National Electrical Safety Code

Interpretations

1984 — 1987 inclusive

National Electrical Safety Code Interpretations

Fig IR 367-1

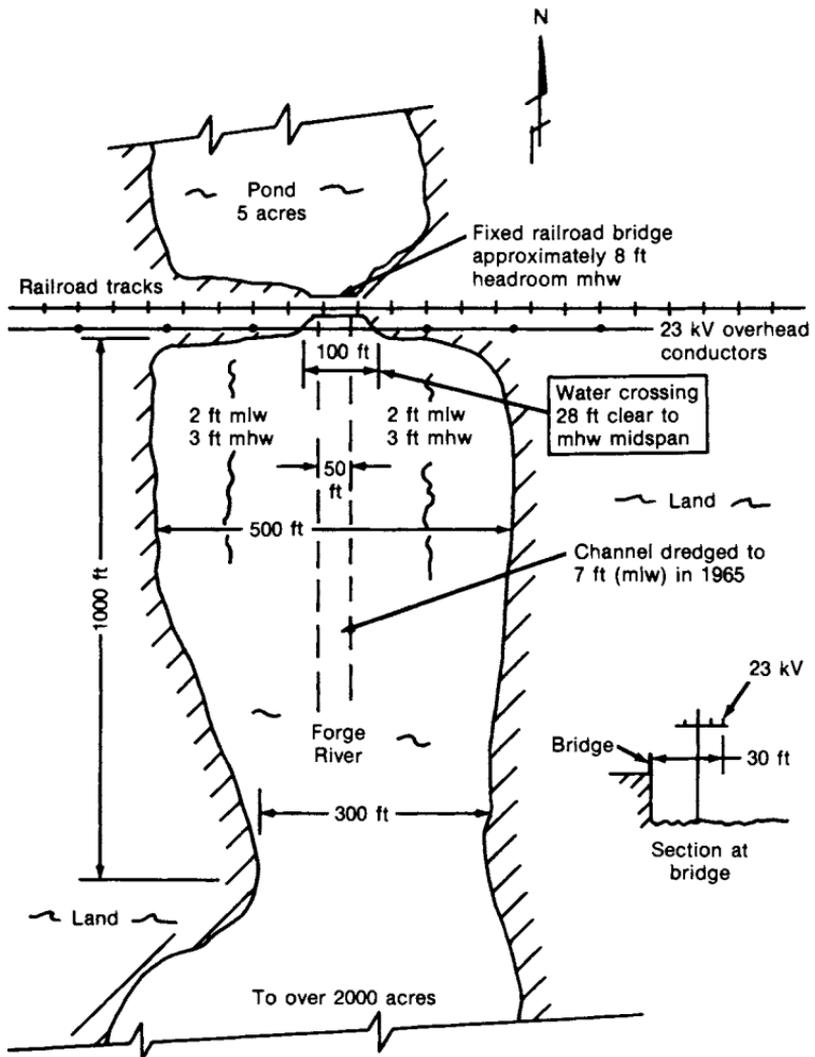
In Figs IR 367 1-3, which show a 23 kV line crossing the north end of a river blocked by a fixed, low railroad bridge, would that area be considered "suitable for sailboating?"

Our interpretation is that while the water under the conductors does not seem "suitable for sailboating," a sailboat under power—or out of control—could possibly contact the line; and since the river flows into another area greater than 2000 acres, the minimum conductor crossing height above the water should be 40 ft.

Fig IR 375

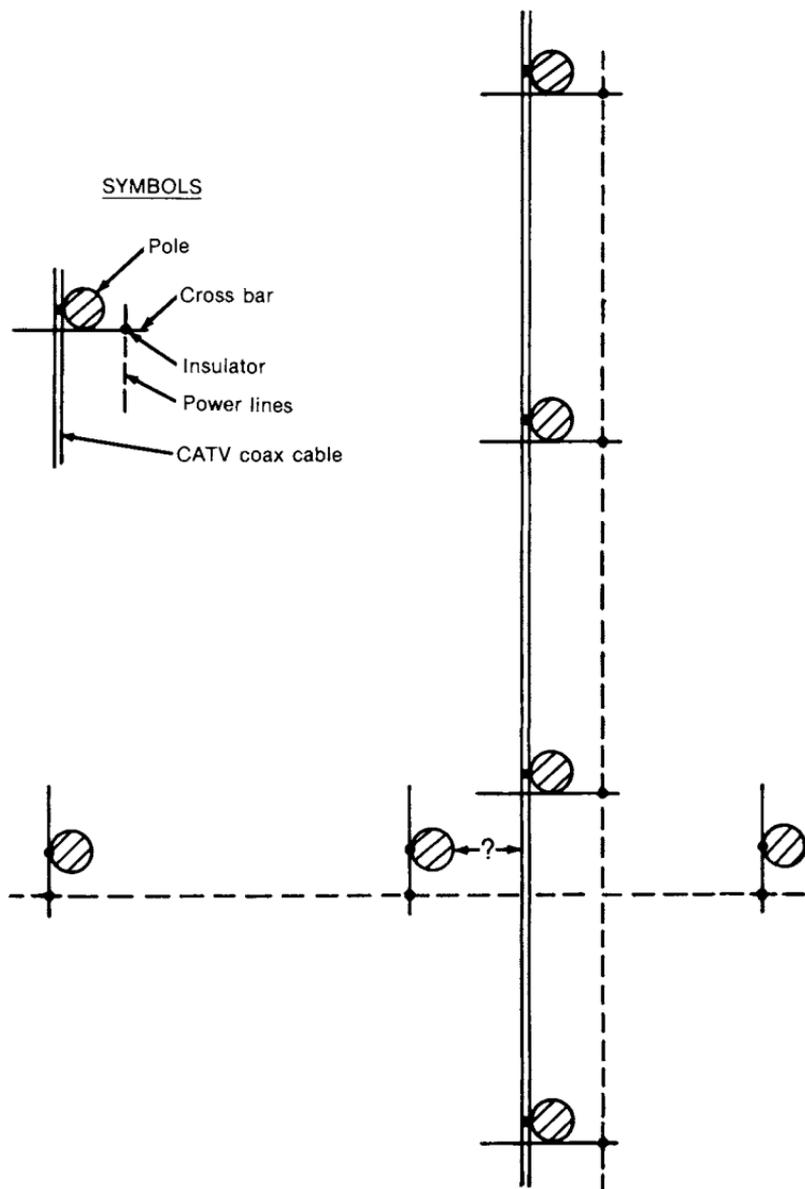
In the case of CATV cables, or other cables that are at ground potential, does the exception to Rule 233B1 apply to the horizontal clearance required by Rule 234B—that is, may the horizontal clearance from a supporting structure, other than the structure that supports the CATV cable, be reduced to either 6 in (150 mm) or 2 ft (600 mm)?

I would appreciate your interpretation of the minimum horizontal spacing at support structures and cables at ground potential.

Fig IR 409-1

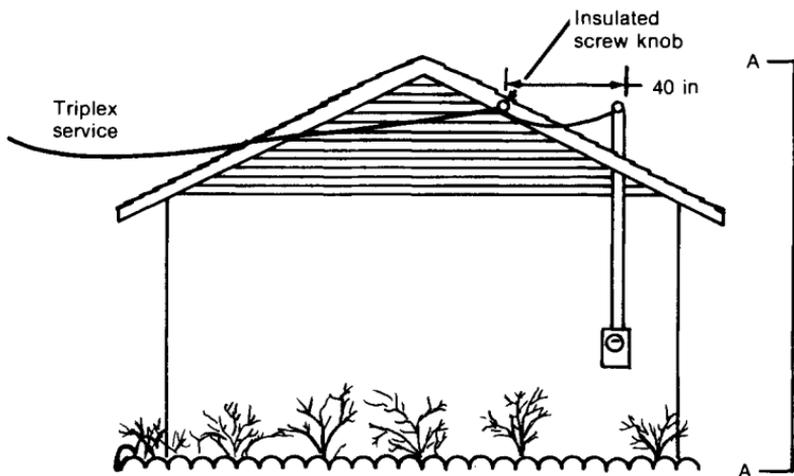
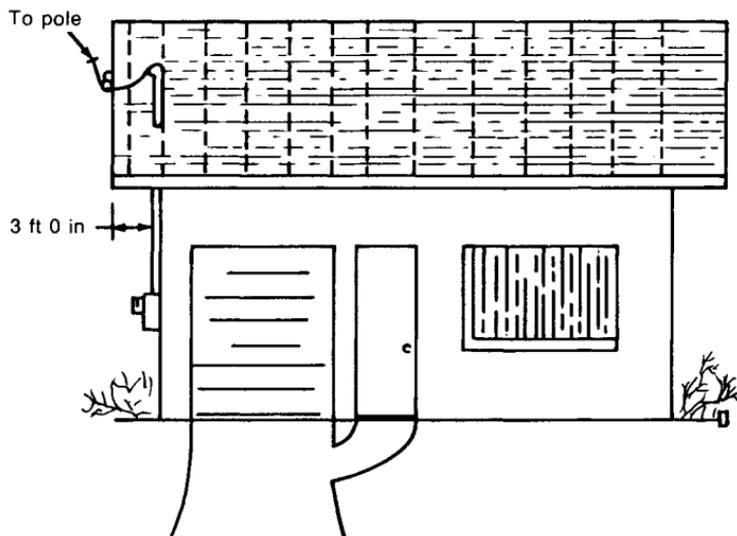
In Rule 234C4 Exception 2, "any portion of the roof" and "overhanging portion of the roof" are both mentioned within the same sentence. Please clarify if "any portion of the roof" refers to the overhanging portion of the roof only.

Also, I have enclosed drawings (Figs IR 409-1 and IR 409-2) of a triplex service attachment using an insulated screw knob on the end of the house for point of attachment. Is the service wire between the screw knob and the weatherhead in violation of the NESC?

Voltage Cable Connection at North Abutment
Fig IR 383-1

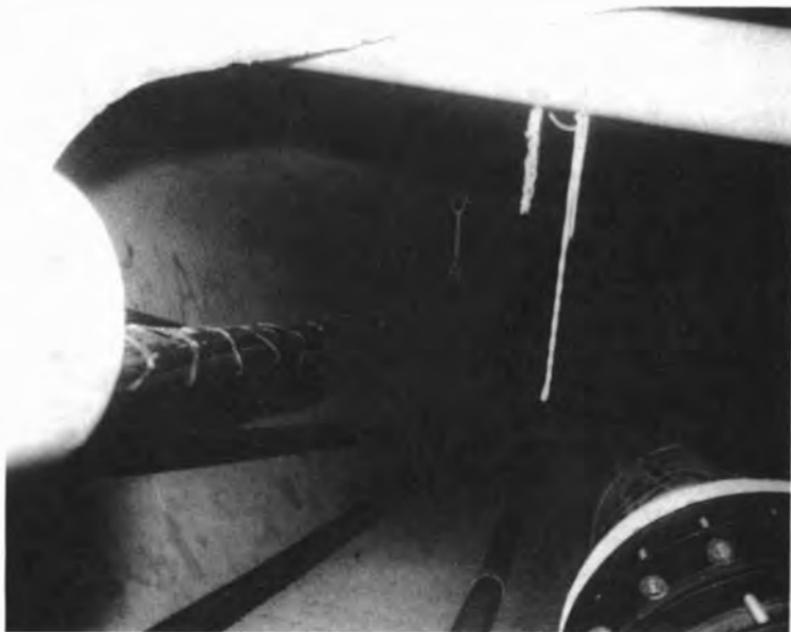
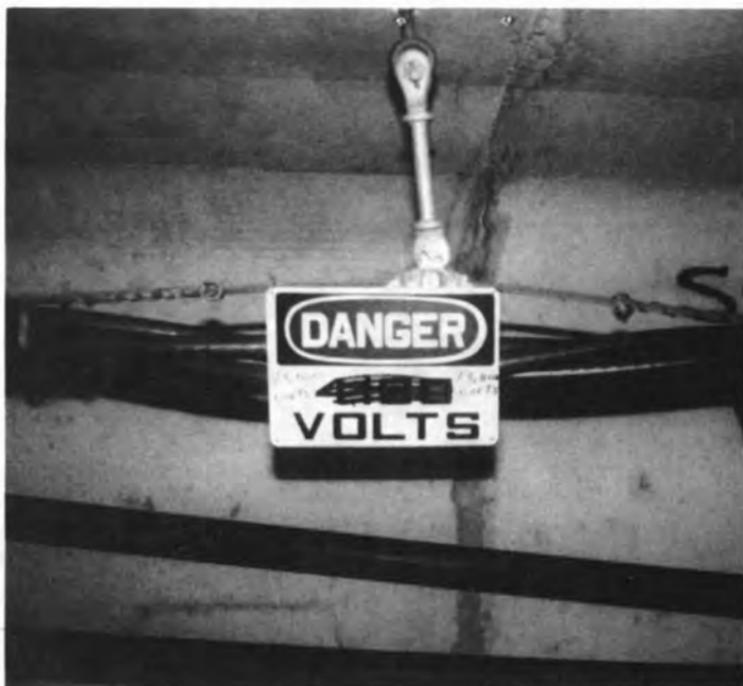
To comply with Federal and State statutes, the Department's bridge inspectors must periodically inspect every square inch of surface area inside the superstructure void. With temperatures inside the void ranging to the high 90s and with very little air exchange, the sweaty inspectors feel some concern for safety when crawling between the watermain and electrical distribution line. They also feel uncomfortable inspecting under and behind the electrical lines.

Maintenance personnel have expressed the same concerns while working on the watermain expansion joints. They feel that it is very unsafe to work on a steel waterline with steel tools when some of the tools may come in contact with the electrical distribution line.

Since neither the bridge inspectors nor the watermain maintenance personnel that must work in close proximity to this electric line are qualified electricians, the Department must determine if this electrical line is constructed in conformance with the National Electrical Safety Code, and if the installation contributes a safety hazard.

Several consultants have been engaged to resolve this issue, but each has a different opinion. The basic difference in their findings is in whether this structure should be considered a bridge or a tunnel.

The requirements of Part 3 for supply cable systems include, among other things, Rule 314B, 323B, 340B and 391A3. Rules 314B and 340B require that the conductive surfaces of the cable installation and its mounting equipment be effectively grounded; the photographs supplied do not show evidence of bonding of these facilities, either together or to the communication facilities, nor is there any other evidence that the installation is, in fact and deed, effectively grounded. Rule 323B requires 3 ft wide by 6 ft high workroom; such dimensions do not appear to be available on the supply/telephone side of the space. Rule 391A3 requires the design to avoid unsafe conditions due to induced voltages; there is no evidence presented to indicate that the voltage potential difference between the surface of the supply cable installation and the other facilities would not be such as to be dangerous to persons bridging the gap between such facilities. If these rules are met in fact, then only the provisions of Part 3 apply. However, the appearance is that one or more of these rules is violated by the supply cable installation and, therefore, the applicable requirements of Part 2 must be met.

Fig IR 378-1
Normal Clearance at the Pole
(RULE 235C1)

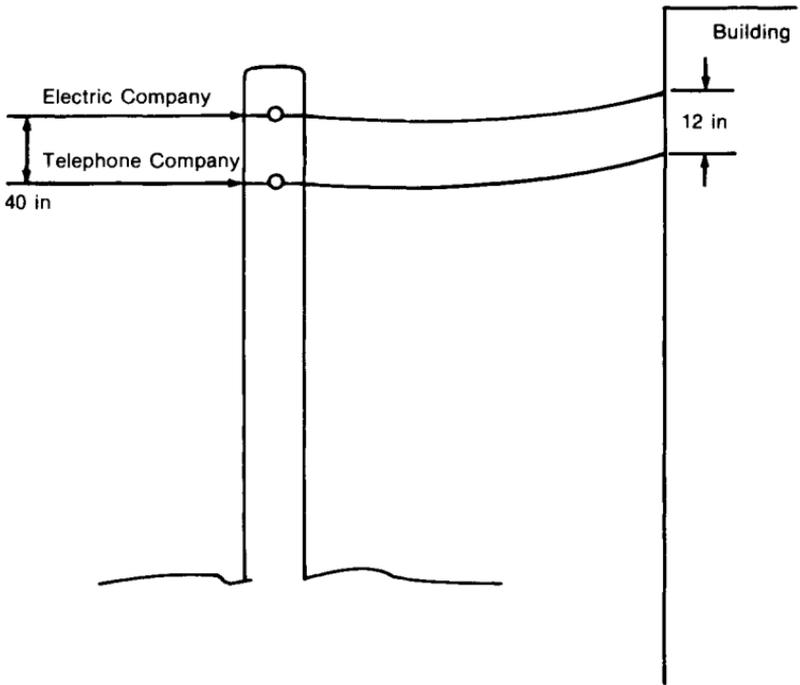
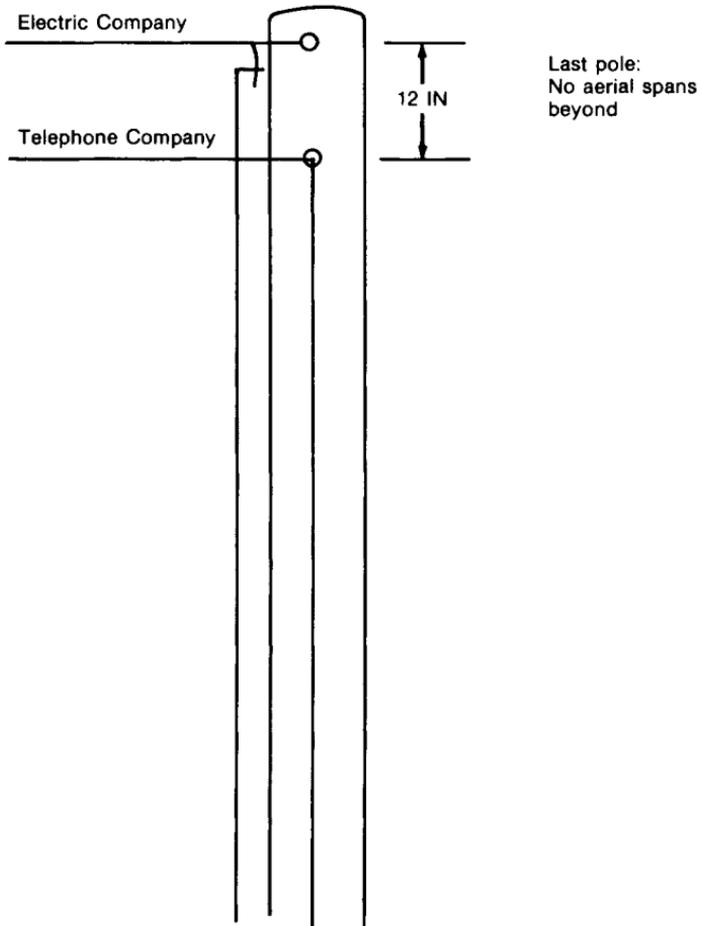
Rule 235C, Exception 3 states that supply service drops of 0-750 V running above and parallel to communication service drops may have a minimum spacing of 12 in at any point in the span and at the point of attachment to a building. This exception also states that there must be 40 in between facilities at the pole. Further research shows that this 40 in is established to minimize the possibility of accidental contact between conductors in the span, even under heavy loading conditions, and additionally provides clear working space between the two types of facilities.

My question, which relates to Figs IR 378-1 and -2 is, if the point of connection is at a pole, such as in Fig IR 378-2, and there are no additional aerial spans beyond this pole, then why would not 12 in between service drops suffice? This thrust of the 40 in requirement and its intent does not exist under the above situation.

Fig IR 362-1

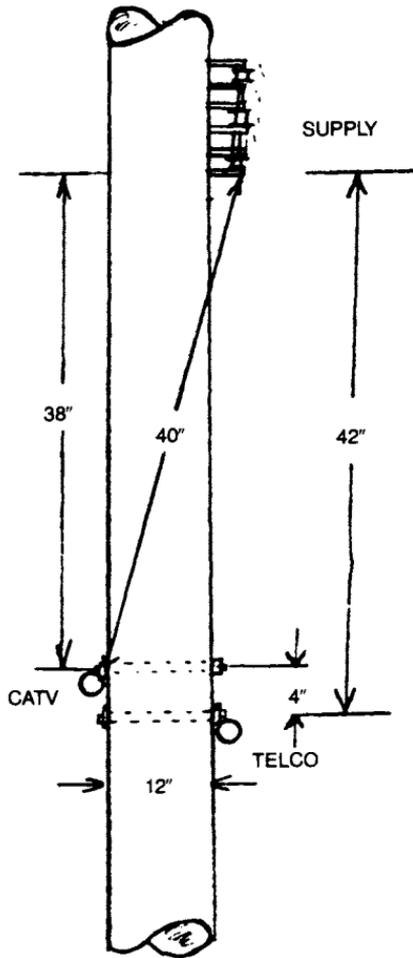
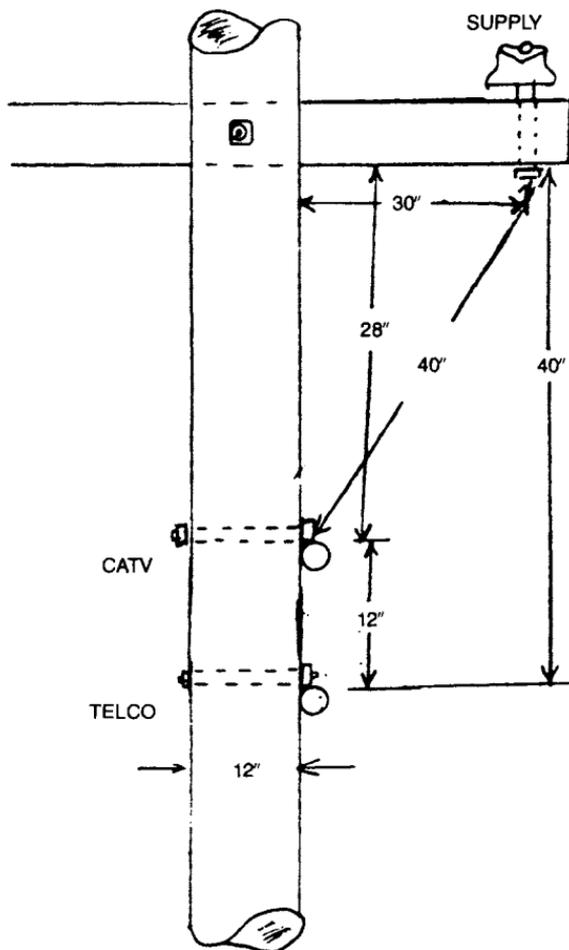
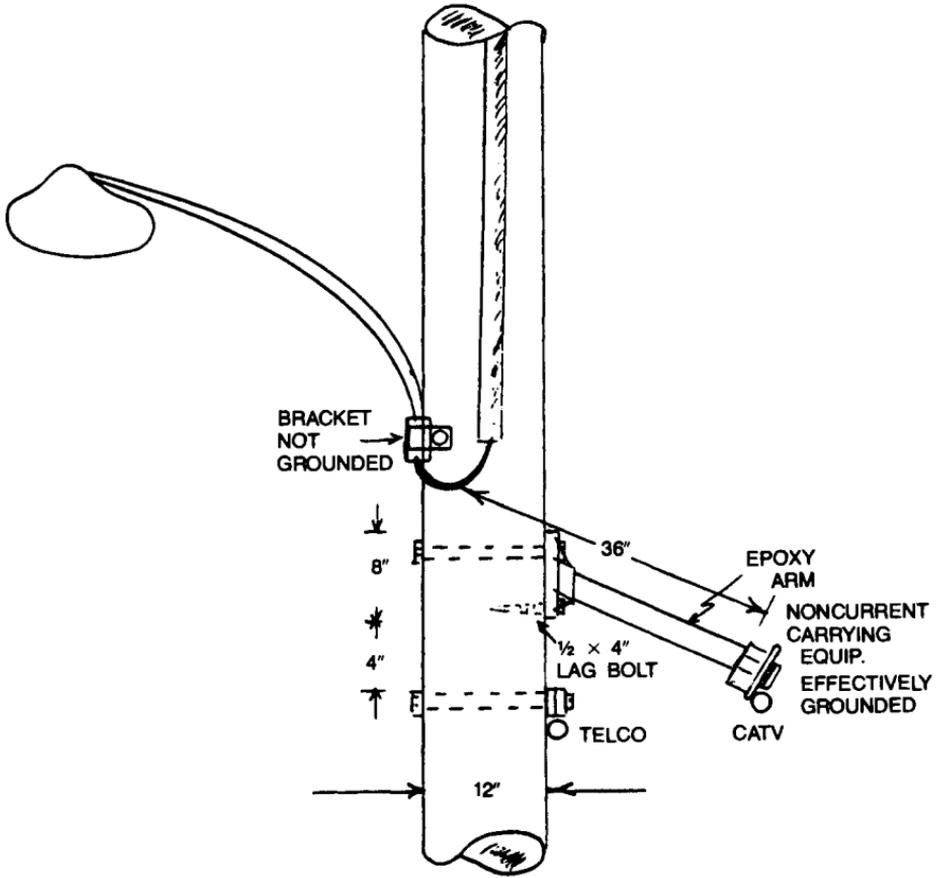
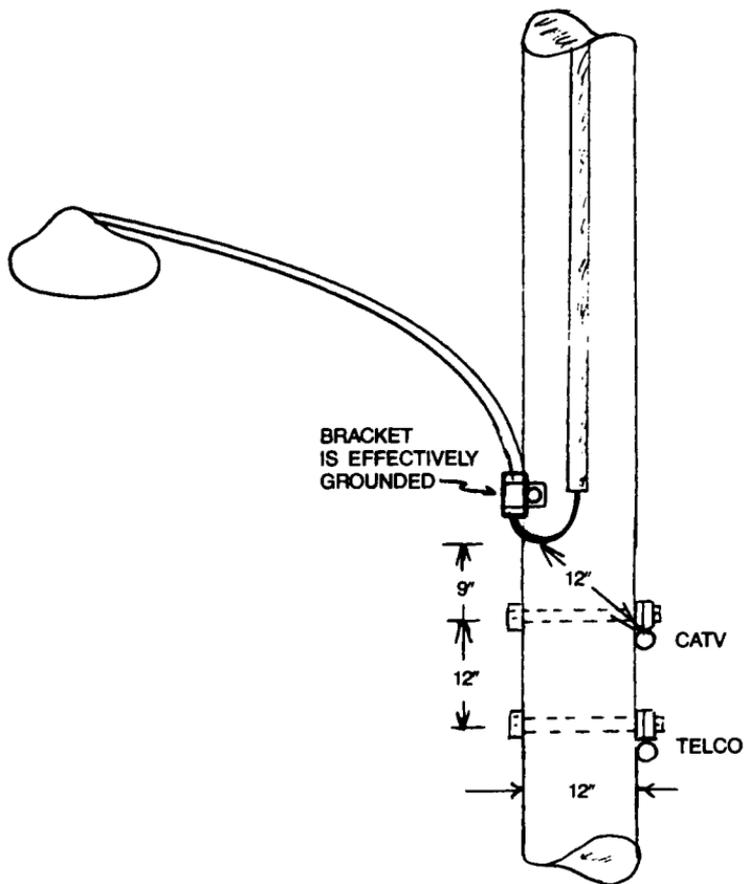
We also believe that the history of physical plant has always been to measure clearances in a vertical plane of all cable, conductors, and equipment mounted on the same support structure in the same plane.

We therefore maintain that it is reasonable to consider measurements for clearances from surface to surface of noncurrent carrying metal parts, whether those parts or surfaces be in the same vertical plane or adjacent vertical planes as indicated in the attached enclosed examples, and still maintain a clearance equal to that necessary to protect communications personnel working on their facilities.

The vertical clearances of Rules 235 and 238 are to be applied vertically, not diagonally. Rule 235D and Fig 235-1 make this quite clear. This requirement produces, among other things, a "box" that provides adequate headroom for communication employees under supply facilities that are or may become energized. This question was effectively answered in IR 268, was considered in subsequent Code revisions, and remains unchanged.
